WESTSIDE SUBWAY EXTENSION PROJECT

Contract No. PS-4350-2000

Response to Preliminary Review Comments of Century City Area Fault Investigation Report by Shannon & Wilson

April 17, 2012

Figure A-9: Transect 4, Century City Fault Investigation

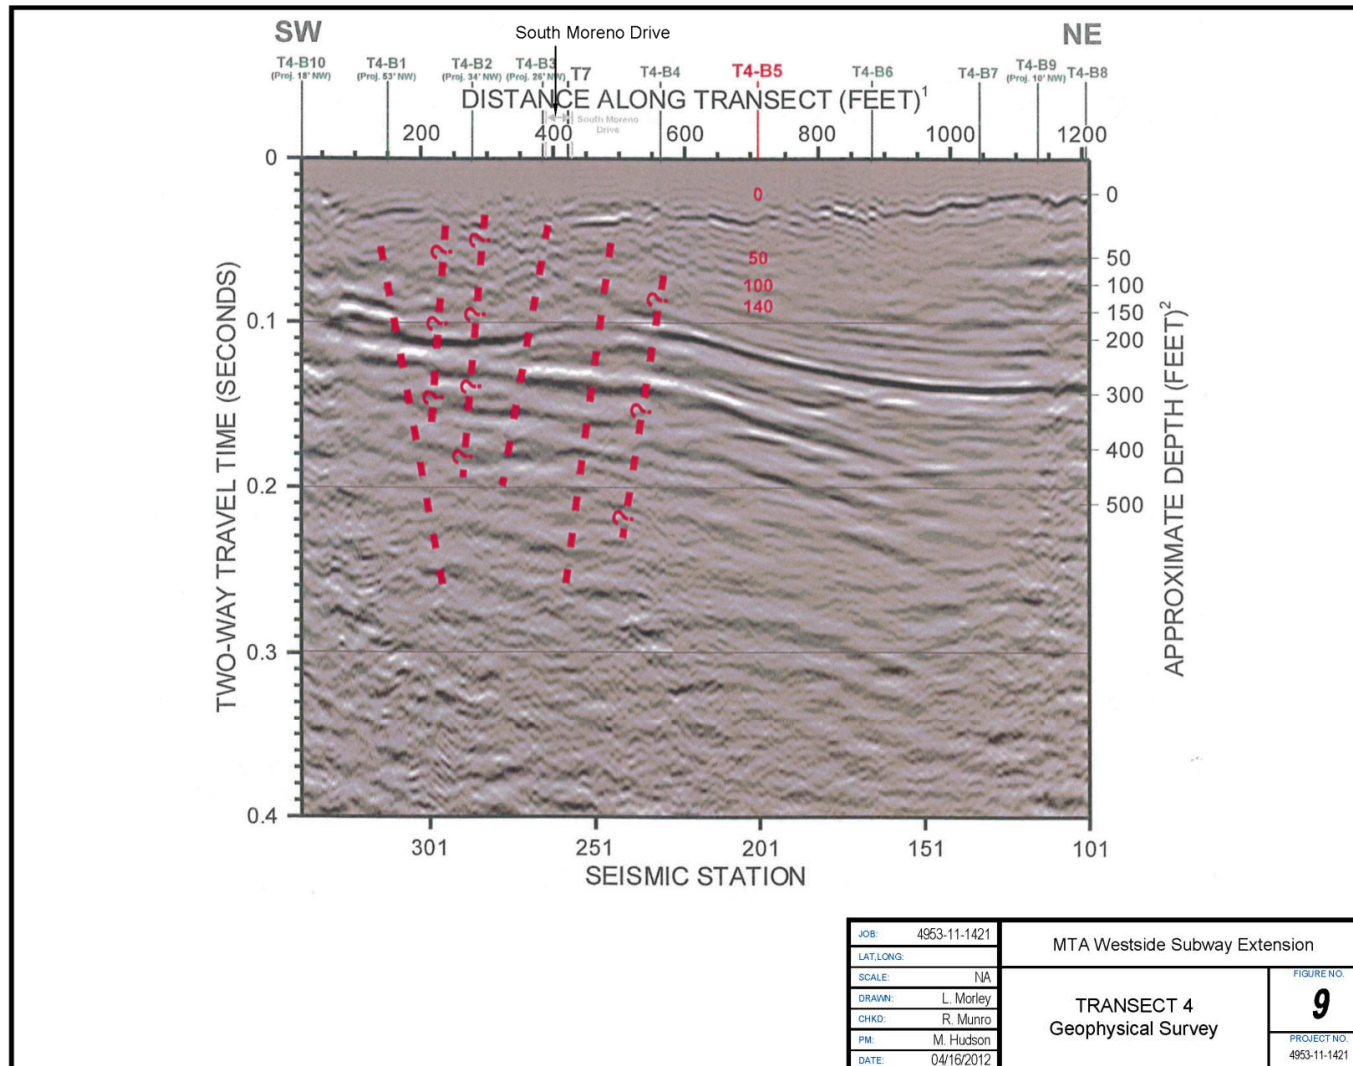
Shannon & Wilson questions the presence and activity of the West Beverly Hills Lineament based on trenching performed at the BHHS campus.

The data from that investigation—described, in part, by the letter report by Roy J. Shlemon and Associates, Inc. (Appendix B)—are not available to Metro so comment cannot be made on them. However, the results of that investigation would not preclude the presence of faults of the WBHL in Santa Monica Boulevard. Based on the closely spaced borings and CPTs, the seismic reflection data, and the review of historical topographic maps and aerial photographs performed in Metro's investigation, there are unquestionably faults present in Santa Monica Boulevard. These faults are clearly seen in the geophysical survey line Transect 4 shown on Figure A-9. The difficulty is determining the level of activity of the faulting.

Figure A-10: Transect 2, Century City Fault Investigation

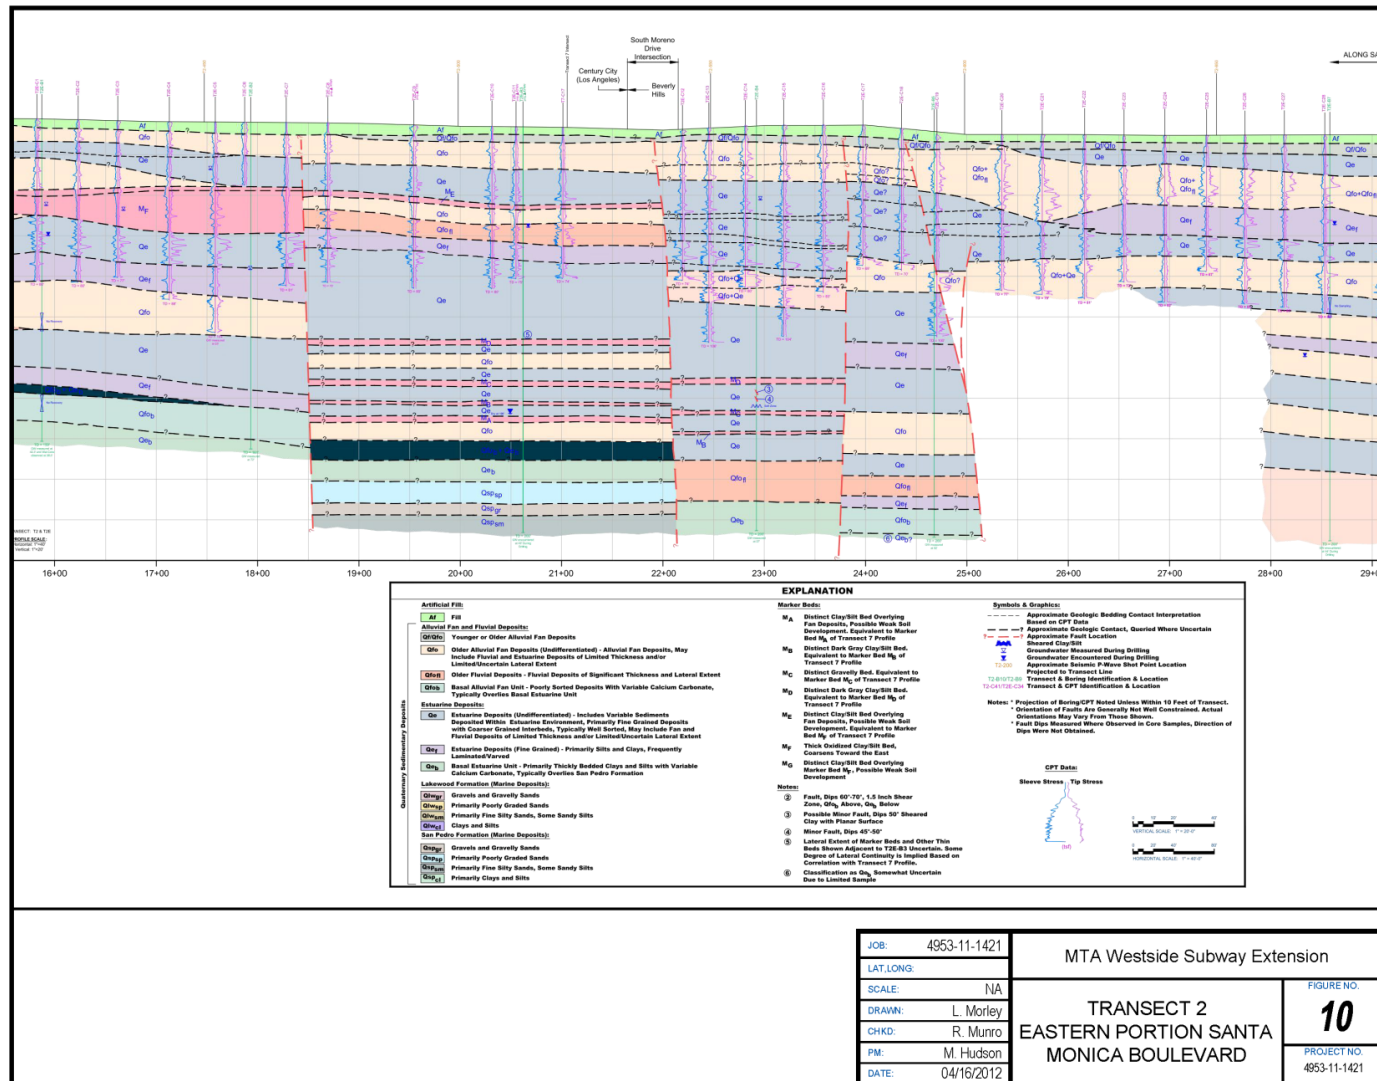
property) would not address the area at the intersection of Santa Monica Boulevard and South Moreno Drive, where significant fault offset was observed in the borings, CPTs, and geophysical survey line (second fault from the left on Figure A-10). In addition to the 10 (or more) north-south trending utility lines in the intersection, there is a 20-foot-wide box culvert more than 24 feet deep in South Moreno Drive at the intersection (Figure A-11). Excavation of trenches to emplace these subsurface utilities has destroyed the original layering necessary to identify faults (or the lack thereof), and there is no possibility that undisturbed Holocene sediments that could be used to evaluate the activity of that faulting remain in the intersection.

Figure A-13: Subway Station East of Moreno Drive

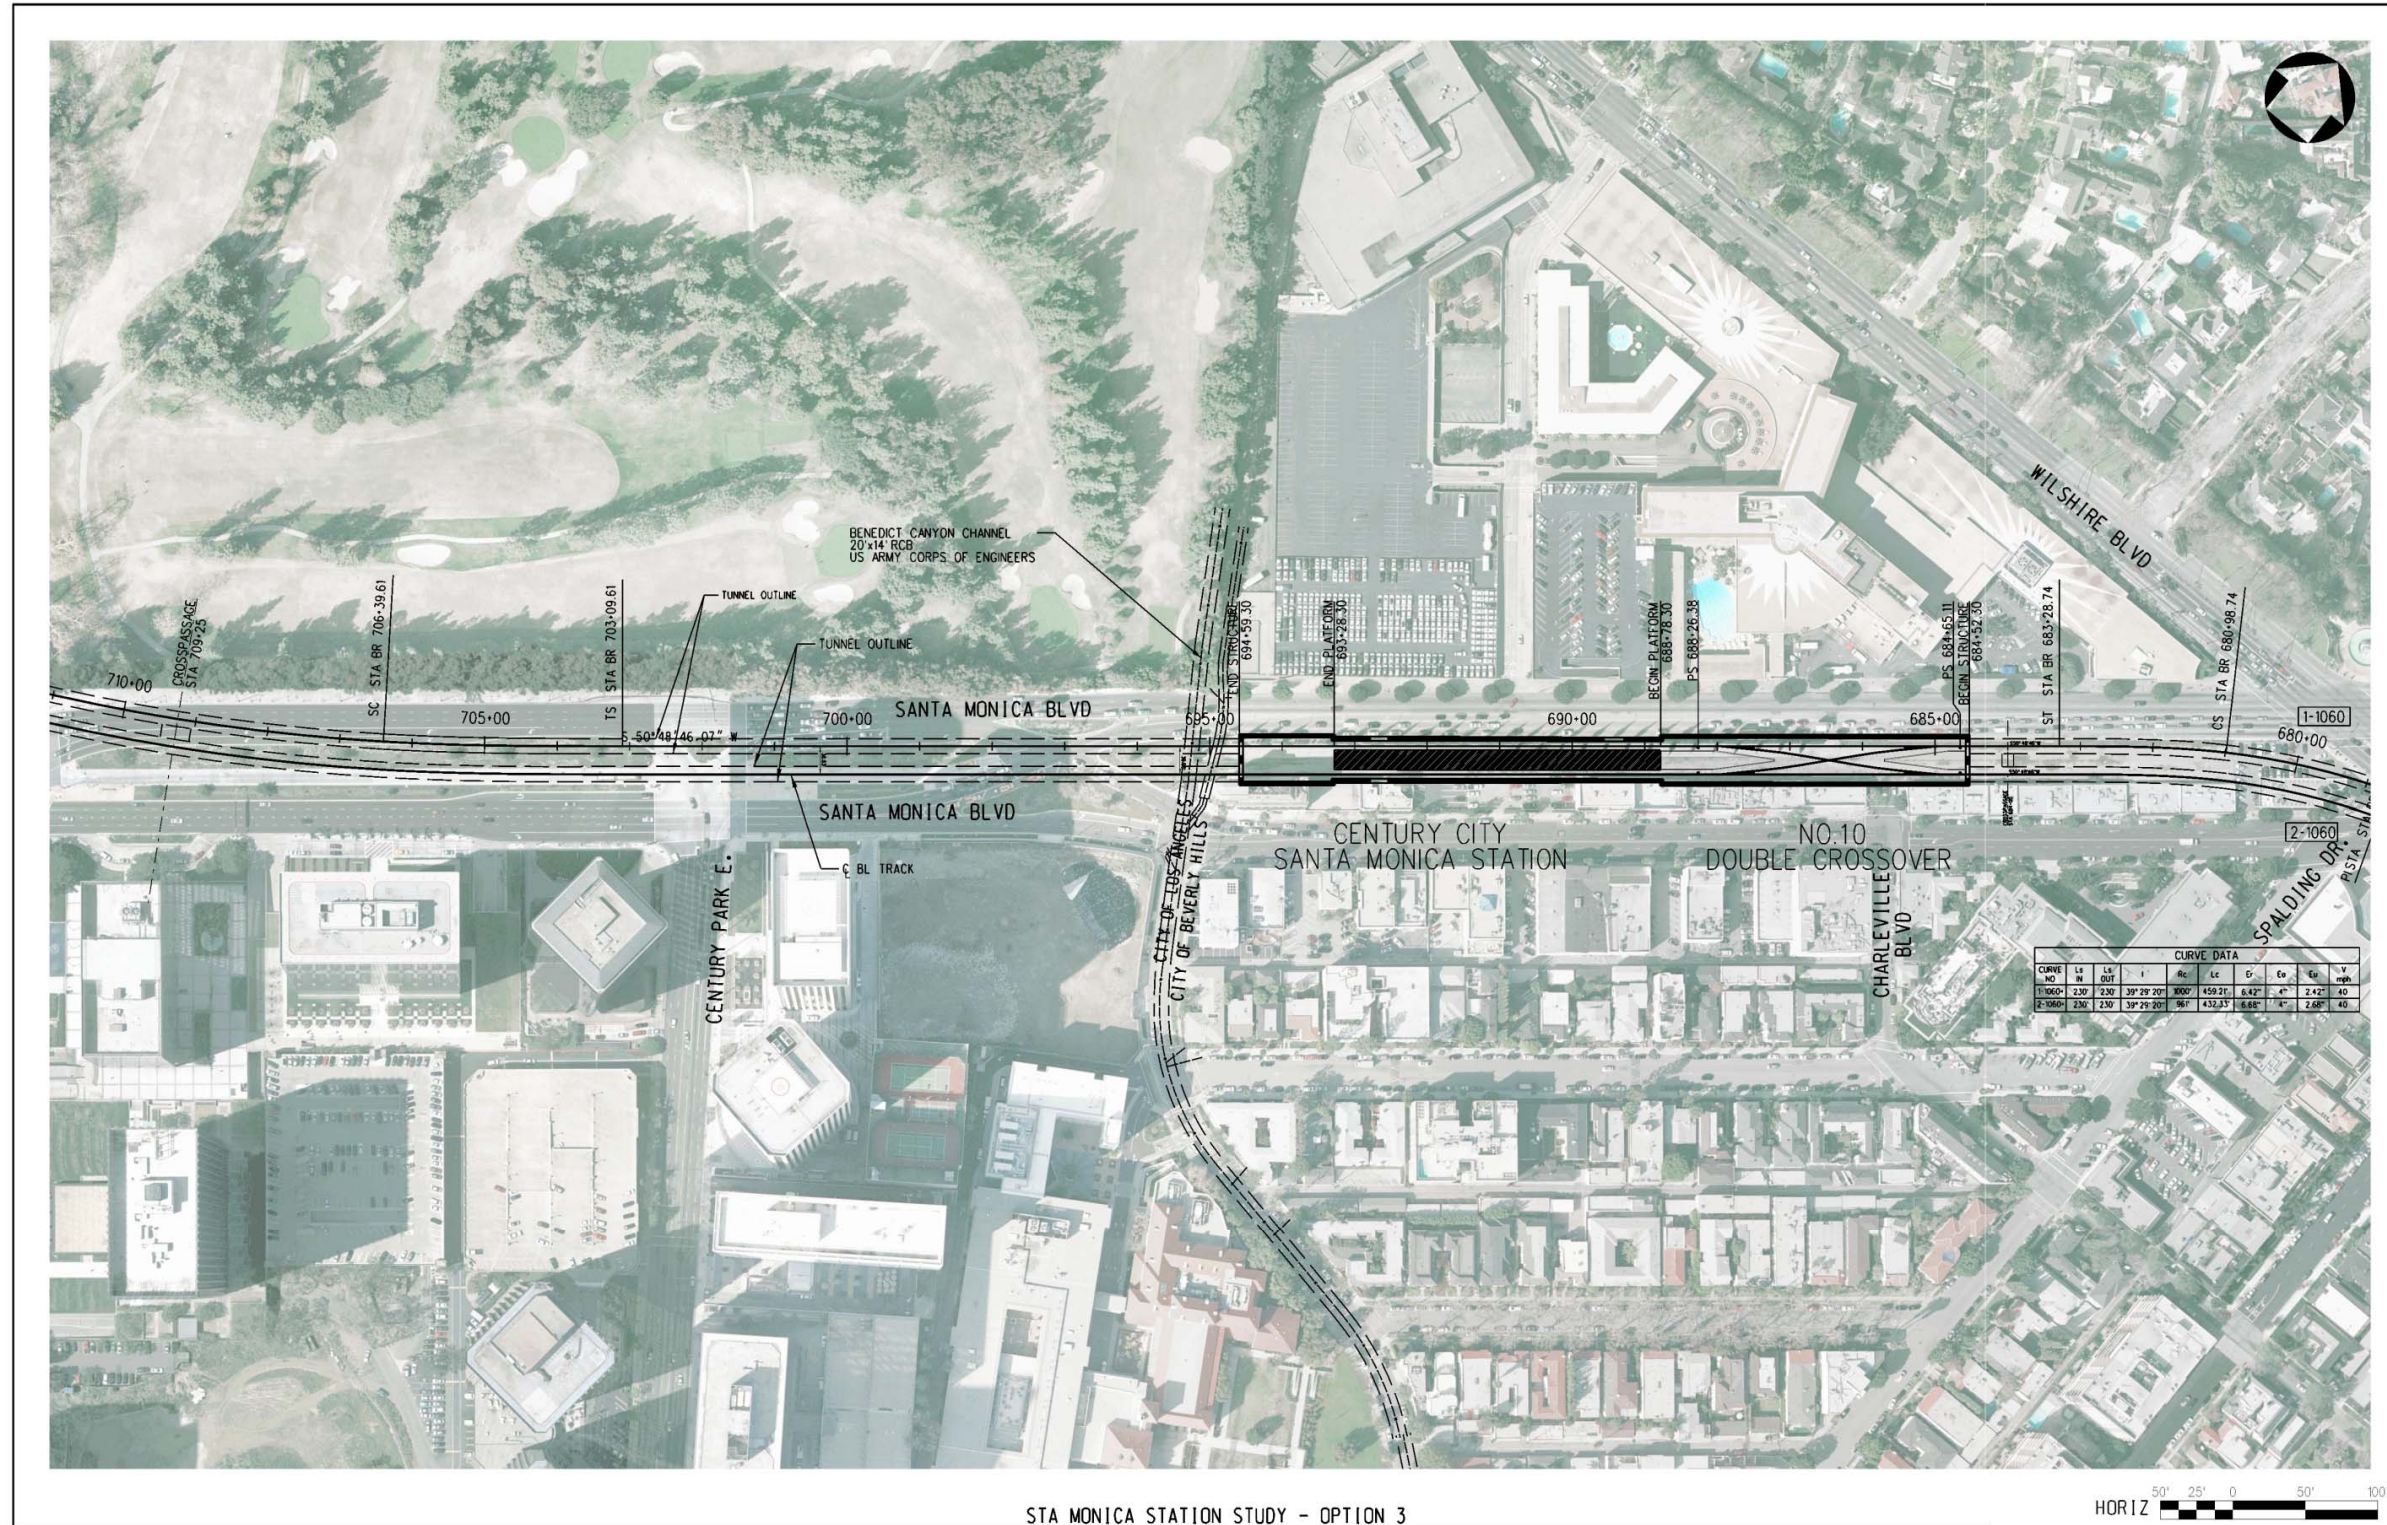
Shannon & Wilson described what they believed were some alternative station configurations that should be investigated: moving the station on Santa Monica Boulevard farther to the east; the other, to consider at-grade (surface) options. Metro has looked at these as well as an aerial station concept.

The first alternative, moving the underground station to the east, is shown in Figure A-13. The station has been moved northeast to just clear the Benedict Canyon box culvert in an attempt to clear the fault zone (refer to Figure A-14 for the station against the fault zone locations), but portions of the station platform would remain in the fault zone. There is just enough room at that location to fit the station box and crossover and still have room for a reasonable curve onto Wilshire Blvd. The west end of the station structure does not clear the fault zone, but this is as far east as the station box can practically be moved. Aside from being in the fault zone, this does not appear to be a practical solution from a planning perspective because it moves the station entrance farther away from the major pedestrian activity center. The entrance is now more than 700 feet from Century Park East.

Figure A-17: At Grade Platform, Typical Cross Section at Platform

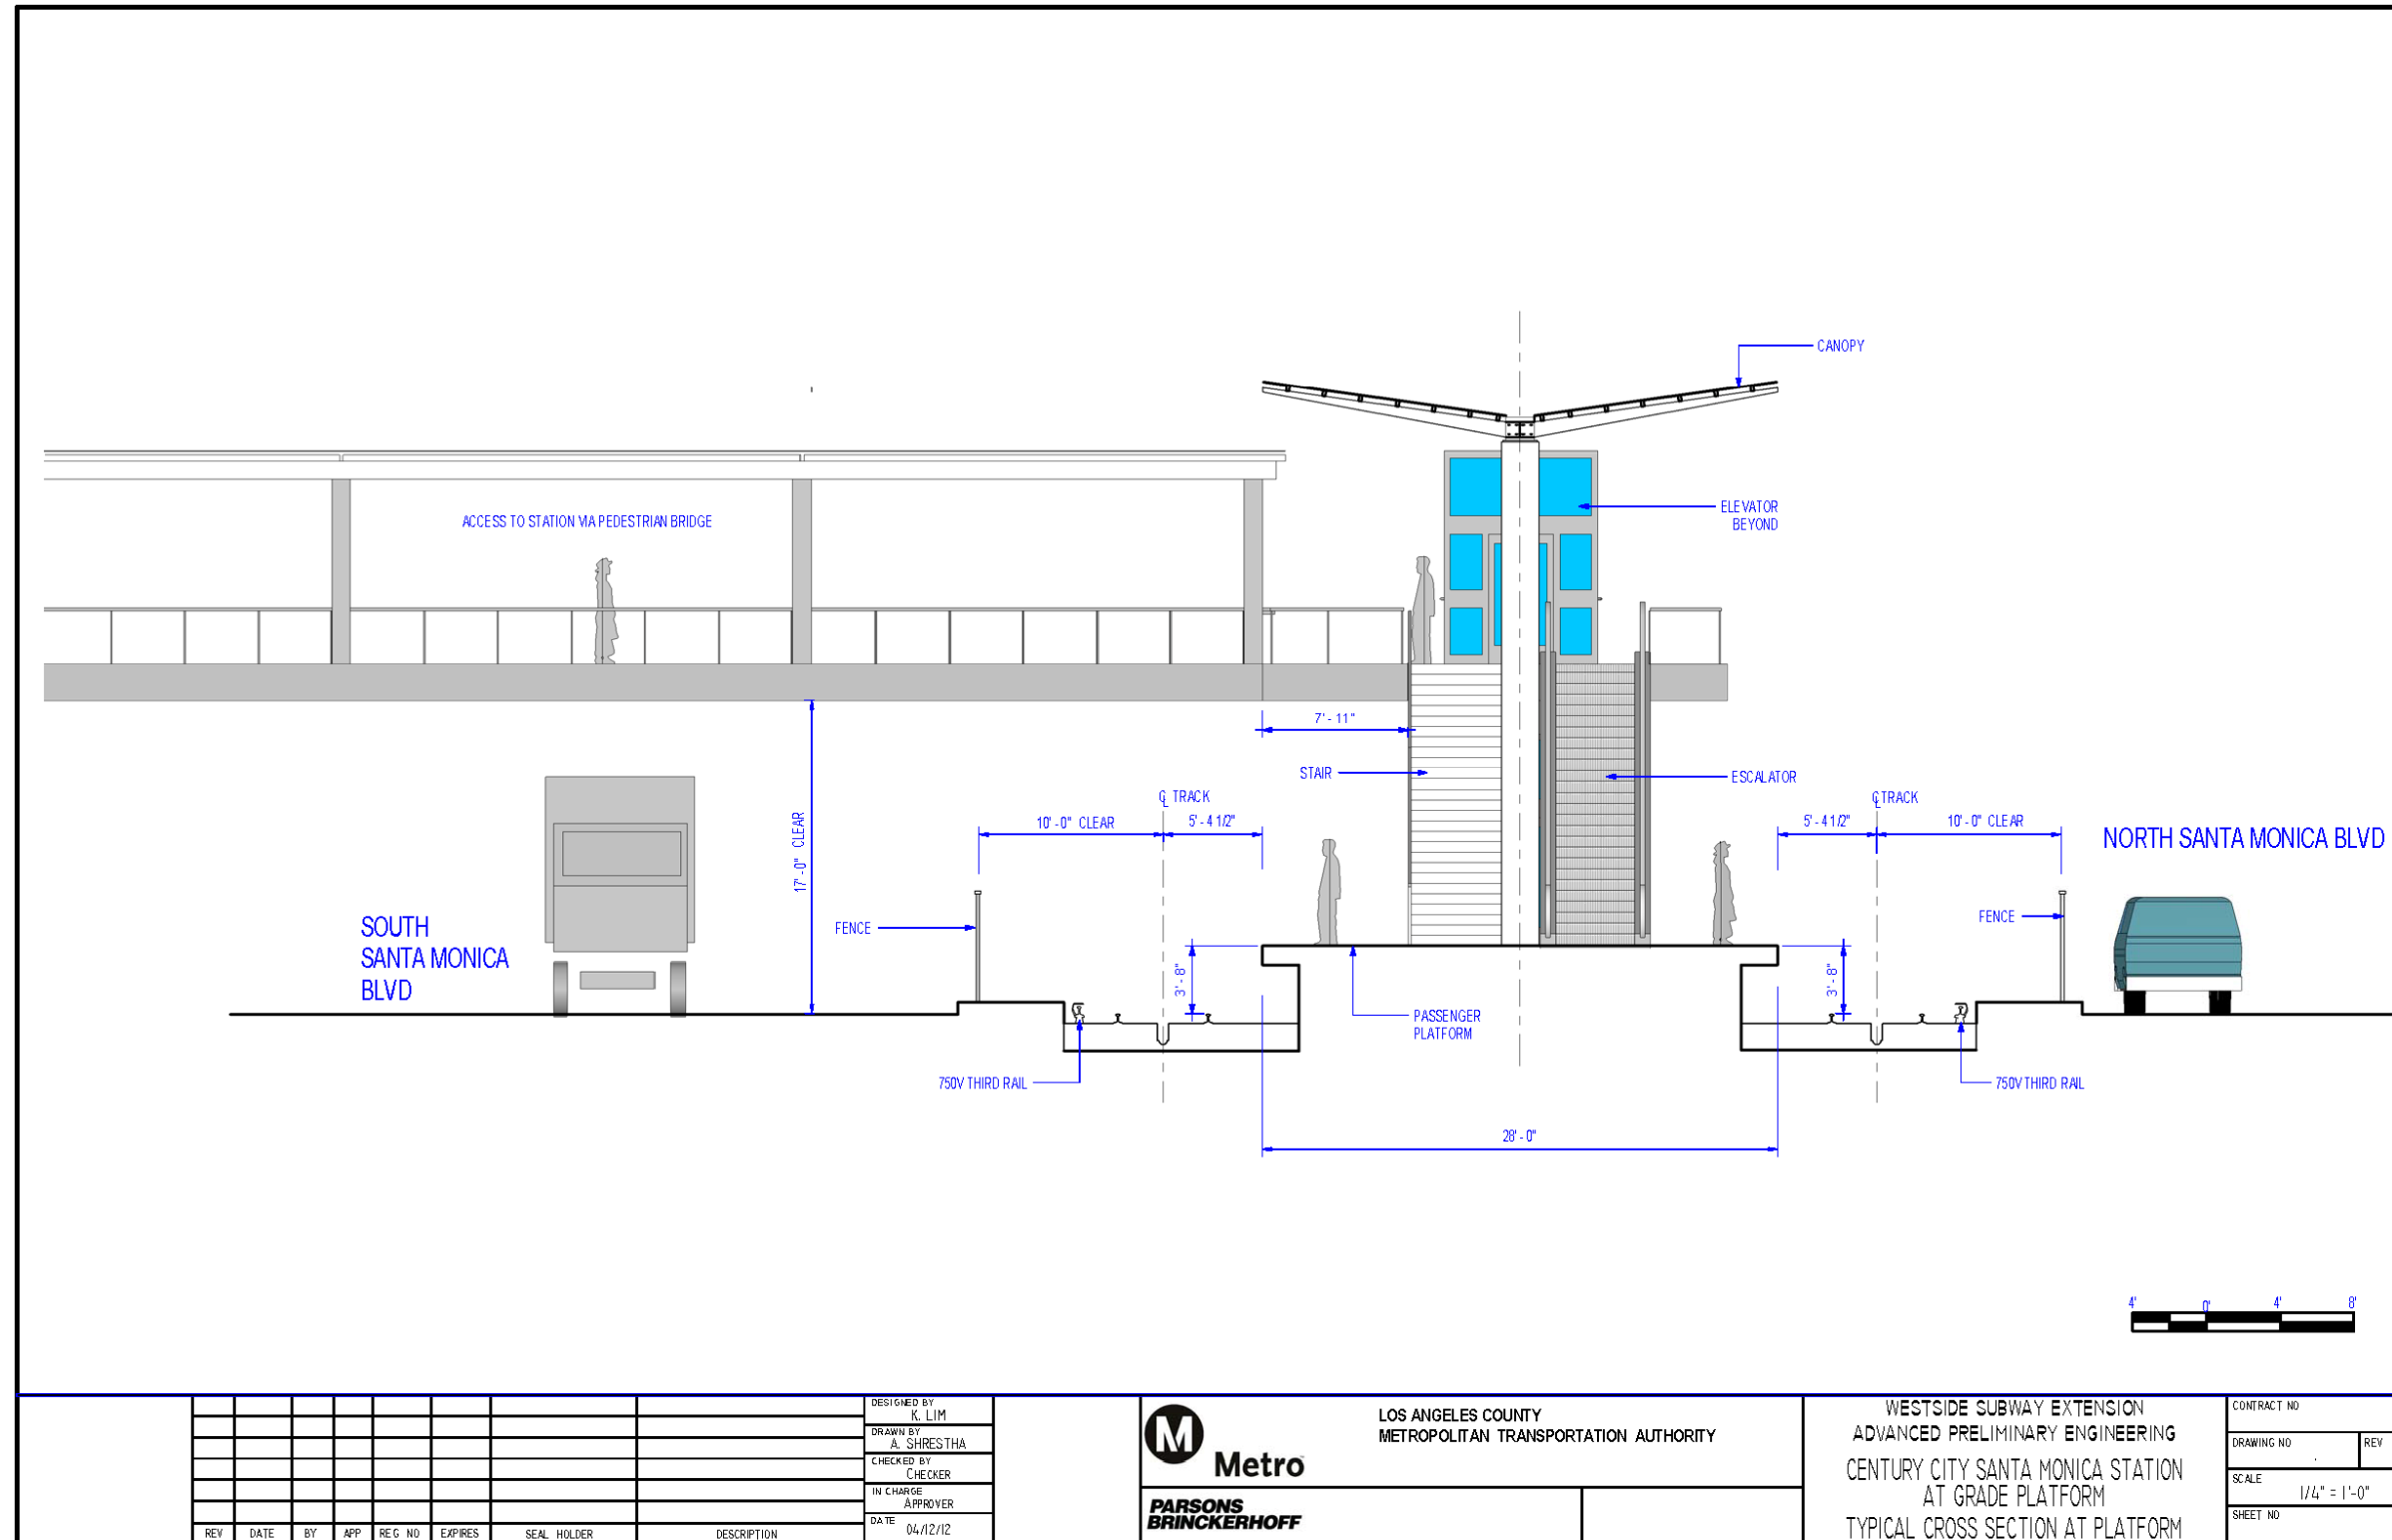
On the West side of the station, another transition trench from at-grade to below ground would be required which would extend for another 800 feet. If the at-grade station were located at Century Park East, the total length of the combination open trench and above-ground section would be over 3,200 feet in length. If the at-grade station were located between Avenue of the Stars and Century Park East, the total length of the combination open trench and above-ground section would be of similar overall length and would extend approximately 800 feet west of Avenue of the Stars. Figure A-16 shows the station located at Century Park East against the Fault Zones. Access to the station platform from Century City would need to be grade separated over the tracks and Santa Monica Boulevard (Figure A-17).
